Display screen for DMU

**European version**

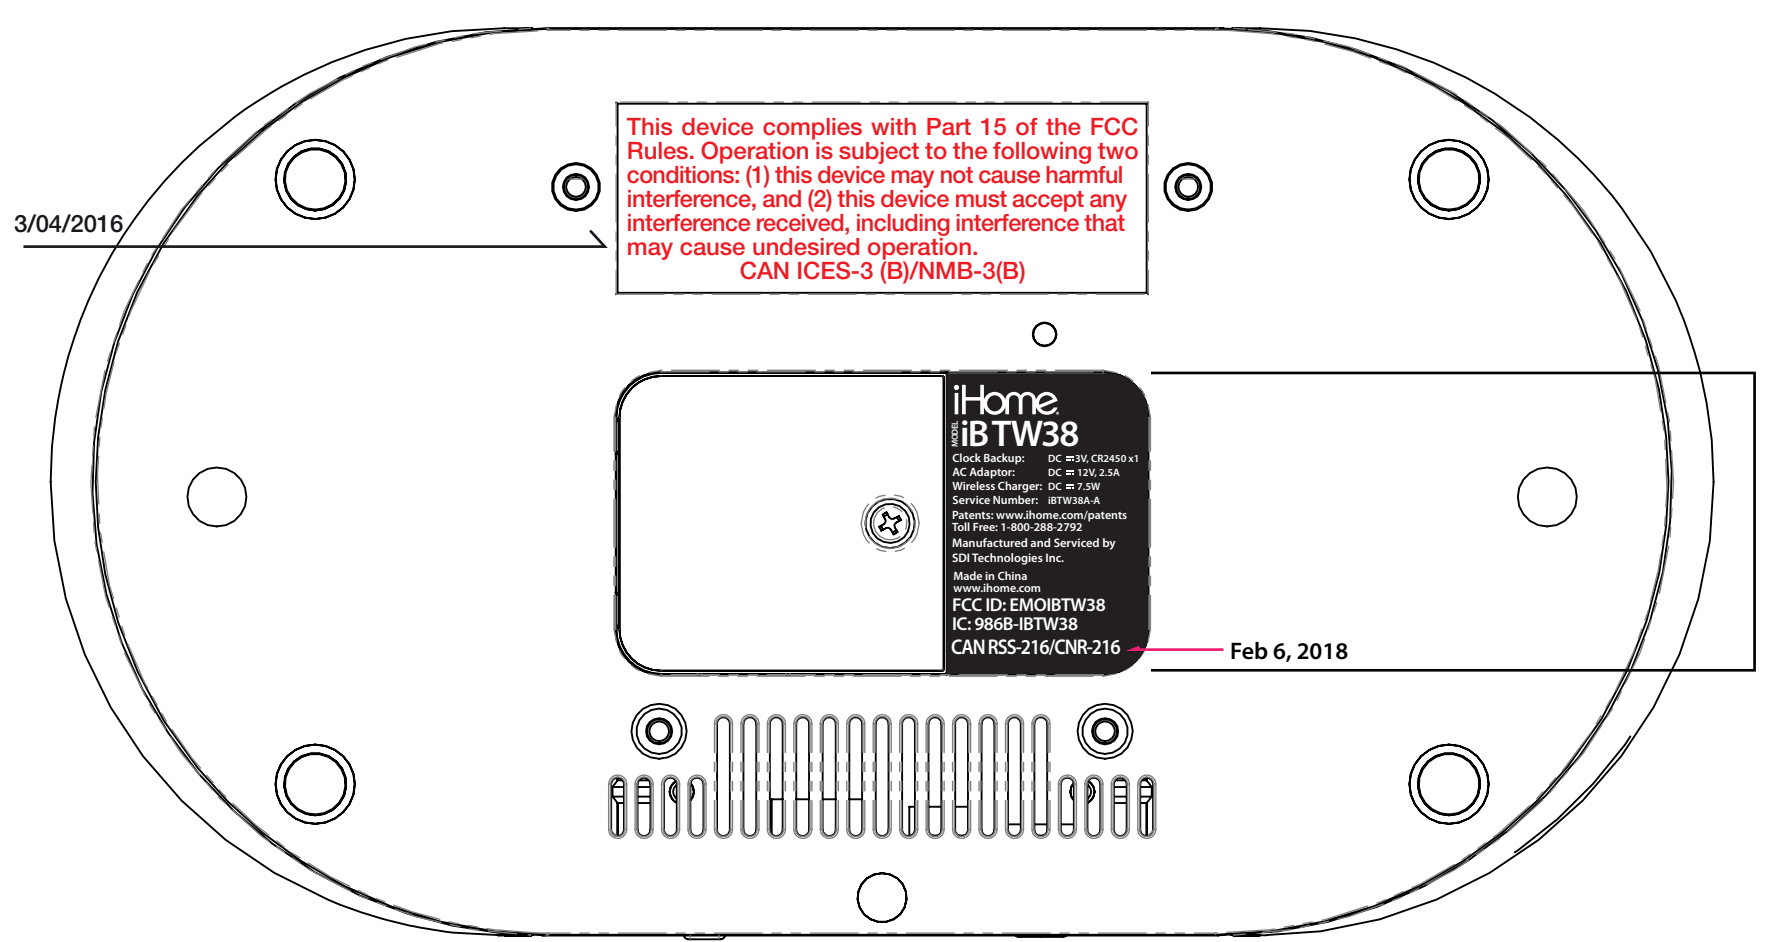
DISPLAY ARTWORK: viewing area is the same as iBTW38. Artwork has changed

the LCD artwork should be screen printed directly on the display lens (Similar to iAV51) instead of using paper sheet behind the lens. Nov 28, 2017

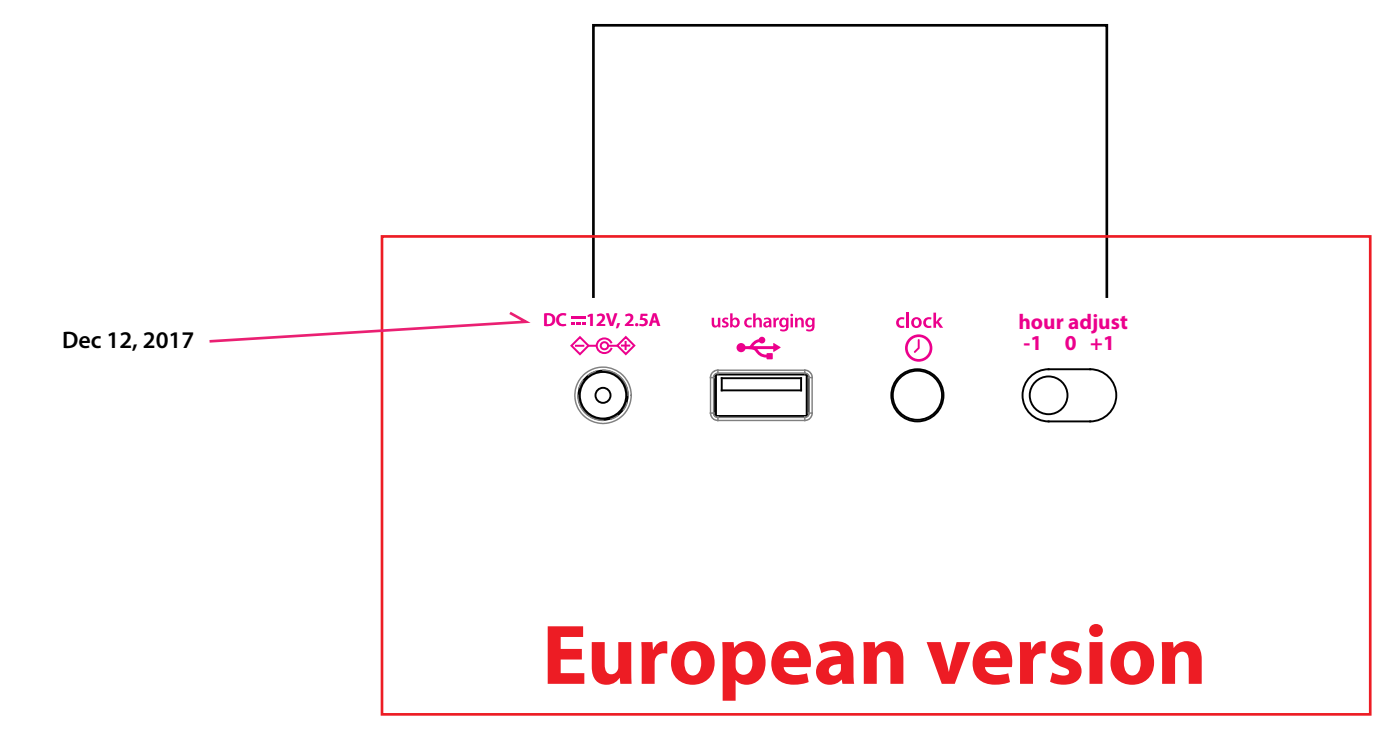
Please note AUX has been removed Rear panel artwork : silk screen graphics see DL for color
